ADDENDUM NO. 2

BUCKEYE PARK TENNIS COURT RECONSTRUCTION Village of Leipsic

March 19, 2019

Buckeye Park Tennis Court Reconstruction

FENCE POST DETAIL

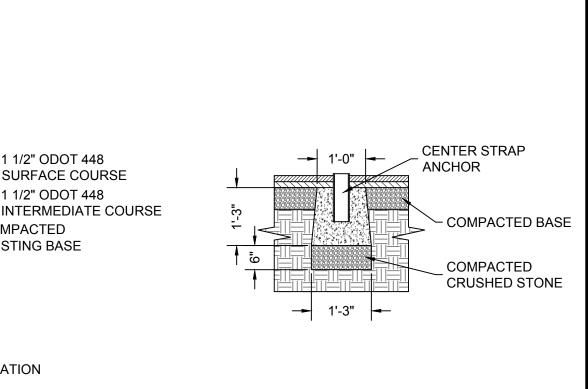
2. NOTES & DETAILS, Construction Plan Sheet #5 of 5

The Contractor will need to provide a fence system that includes a middle rail. Construction Plan Sheet #5 has been updated to reflect this change and is attached.

RAIL (REQUIRED)

03/19/19 - ADDENDUM #2 PROVIDE MIDDLE RAIL
